RE: ICAs for 190th Street Signals and Street Lights

INTERIM CHANGE AUTHORIZATION
CLASS "B" PERMIT PROJECTS

JOB TITLE 190th St. @ Normandie Avenue, SW corner TR. No. 52172

JOB NO. BC-600290 PLAN REF. P-35139 SERIAL NO. SL-1

IN HARBOR/CA952
P-35139
SERIAL/SKETCH NO. SL-1
SHEET OF 5

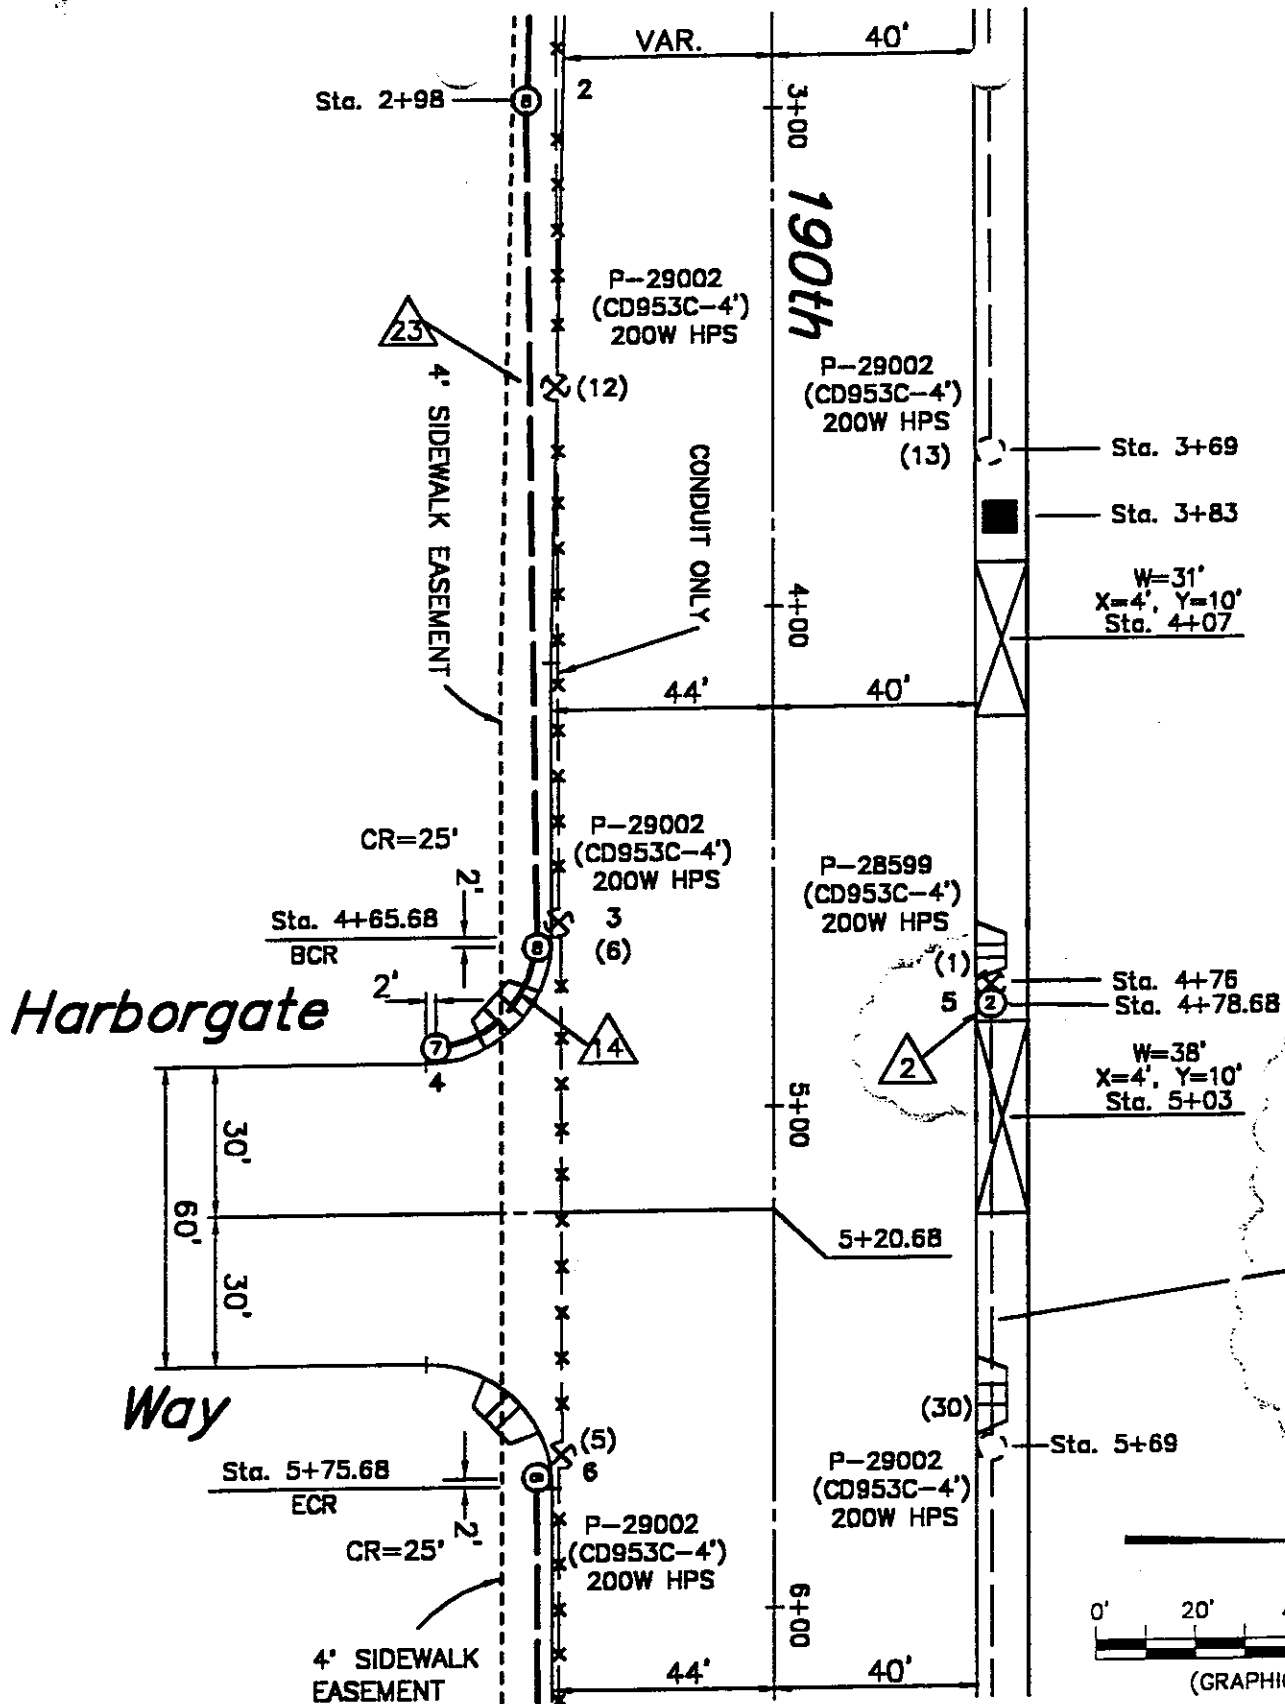
1. The contractor determined that there is not adequate clearance for the 40 foot davit poles shown along the north curb of 190th street on the original plans. DWP re-reviewed the plans and confirmed that contrary to their original review, the clearance required for the approved plans is not available.

2. The following list itemizes the changes to the street lighting plans:
 - o **190th Street and Harborage Way** -- Install a 26-3-70 standard with a custom 30' mast arm and a 310W luminaire at pole location 5 (Sta 4+78.68) on the signal plan instead of a 40' davit pole with a 400W luminaire. (see attached detail).

- o **190th Street and San Diego Freeway S/B Off-Ramps**
 - Install a 26-3-70 standard with a 45' mast arm and a 310W luminaire at pole location 12 (Sta 12+53) on the street lighting plans instead of a 40' davit pole with a 400W luminaire. (see attached detail).

- The existing street lighting standard shown at pole location 9 on the signal plan is to remain instead of installing a davit pole.
 - Chip into the existing foundation and install a 1 1/2" conduit to the proposed pullbox. (see attached detail).

- o **190th and Normandie** -- Install a 26-3-70 standard with 45' mast arm and a 310W luminaire at pole location 18 (Sta 17+53) on the signal plan instead of a 40' davit pole with a 400W luminaire. (see attached details).
